U.S. Department  
of Transportation  
**Federal Highway  
Administration**

March 6, 1998

In your February 17 letter to Mr. Henry Rentz, you requested Federal Highway Administration's acceptance of the California Department of Transportation Type 70 Bridge Rail at the National Cooperative Highway Research Program (NCHRP) Report 350 test level 4 (TL-4). To support this request, you sent us a copy of your report: "Vehicle Crash Tests of the Type 70 Bridge Rail," dated January 1998, and a copy of a video tape documenting the certification tests that were conducted.

**TYPICAL SECTION**

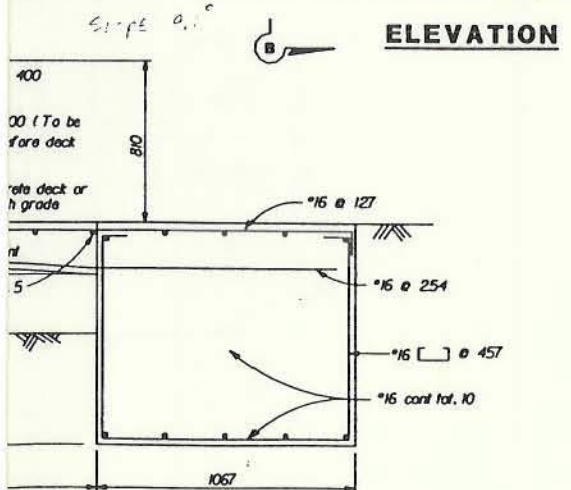
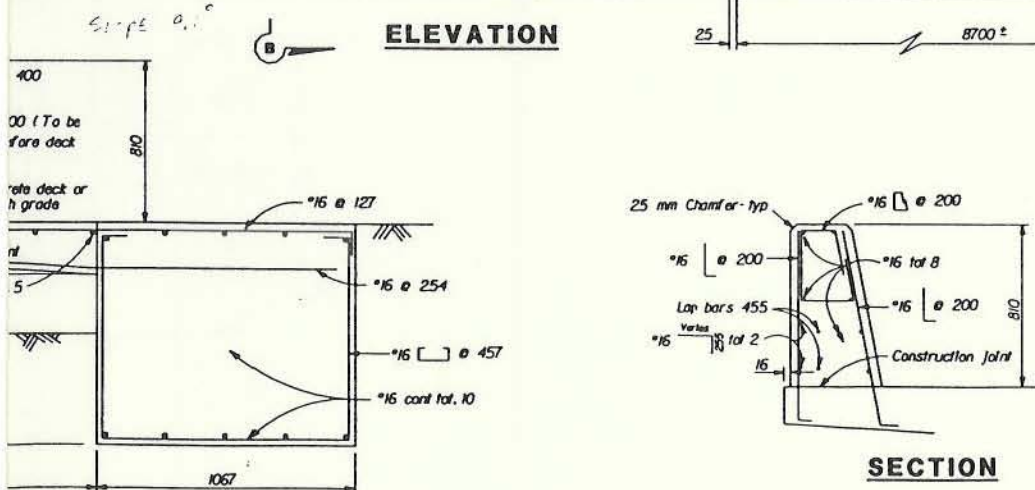
Our review of this material indicated that the Type 70 Bridge Rail is an 810-mm tall concrete barrier with its traffic face sloped at a constant 9.1 degrees away from traffic. This face geometry is identical to your Type 60 roadside/median barrier that was accepted for use on the National Highway System (NHS) at TL-3 in my February 4 letter to you. However, the Type 70 Bridge Rail has a vertical back face with some architectural treatment and is more heavily reinforced than the Type 60. Design details are shown in Enclosure 1.

Based on the above, we consider the California Type 70 Bridge Rail a NCHRP Report 350 TL-4 design that may be used on the NHS when proposed by a State or local transportation agency. Since you did not provide any details on your transition design, nor submit any crash-test results, our acceptance is limited at this time to the design of the bridge rail itself. By copy of this letter, we will advise our field offices of this finding. Please call Mr. Richard Powers of my staff at (202) 366-1320, if you have any questions.

Figure 2.22 - Test 512 Data Summary Sheet

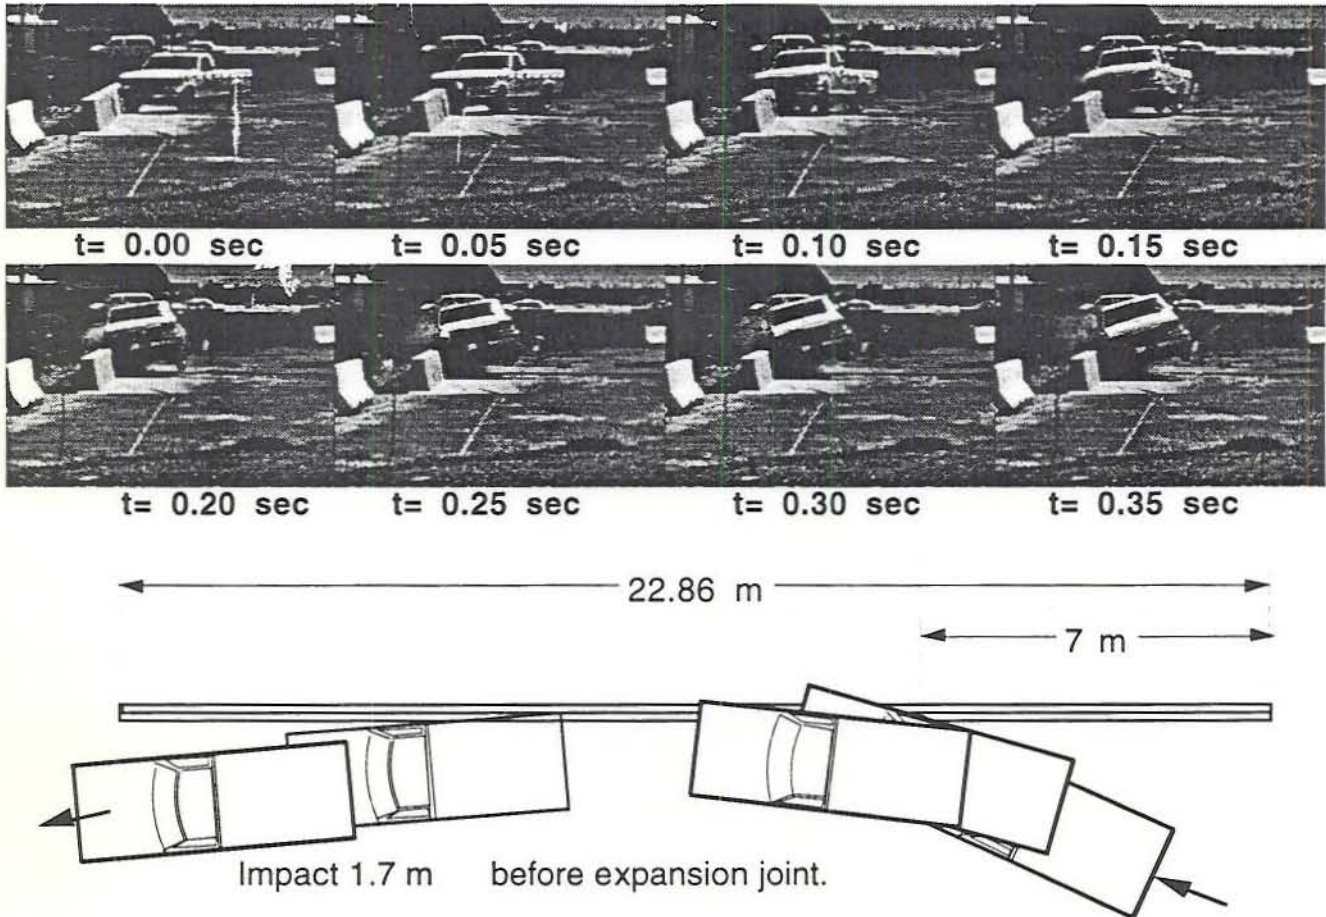
We noted that three tests were reported, including test 4-12 with an 8000 kg single-unit truck impacting the barrier at an angle of 15 degrees and a speed of 80 km/h. Each of these tests met appropriate NCHRP Report 350 evaluation criteria. The individual test results are summarized in Enclosure 2. We noted also that test 4-11 was re-run after a first unsuccessful attempt in which the pickup truck rolled over after impact. You theorized that the non-standard floating rear hub of the test vehicle caused the drive shaft to pull out of the transmission housing on impact and that the shaft then dug into the test track and precipitated the rollover. This test was then re-run with a pickup truck with a standard wheel hub. Considering the successful retest and the earlier pickup truck tests with your Type 60 constant slope barrier as well as successful pickup tests with the New Jersey, F-profile, and the Texas Department of Transportation constant slope barrier, we are willing to consider test 512 (NCHRP Report 350 test 4-11) as an anomaly.
